July 30, 2019

The U.S. Environmental Protection Agency (EPA) participated in meetings with the U.S. Department of Energy (DOE) and the Tennessee Department of Environment and Conservation on July 10, 2019, to review the DOE preliminary design groundwater model for Central Bear Creek Valley Site 7c. The meeting was informative and handouts answered many questions previously raised by comments shared from EPA. Because the model was presented using handouts, the group was unable to run and analyze specific model changing conditions. Questions remain regarding the variability of results.

EPA Comments from the Preliminary Groundwater Model Design Meeting for the Central Bear Creek Valley Site 7c, Oak Ridge, Tennessee

Figure 1. Water table on both sides of a “Drain” boundary during a heavy rainfall event

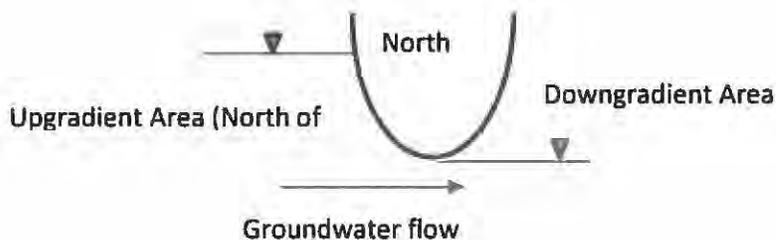
1. A major limitation of the current DOE model is the assumption of a “Drain” boundary for the ditch north of the proposed landfill. The term Drain boundary, as defined in MODFLOW, would restrict any rise of the groundwater table above the bottom elevation of the ditch on the downgradient side, where the landfill is located (see Figure 1). As a result, this model parameter will not allow the water table to rise adjacent and possibly within the landfill footprint during an extreme rainfall event or extended period when the ditch is full. Although it appears that rainfall events are transient and may not have any sustained effect on the proposed landfill, any short term rise in the ditch water level may cause the water table to rise because of the steep north-south gradient. The current model boundary condition for the north ditch should be changed to a “River” boundary, which will allow the model to consider this boundary as a source or sink. By MODFLOW definition, a “River” boundary could act as a “Drain”, but a “Drain” could never be a “River”. Therefore, a “River” boundary for the north ditch could act as a “Drain” (or sink) during average condition, while during extremely or prolonged rainfall events it could become a “River” (or source and head boundary).
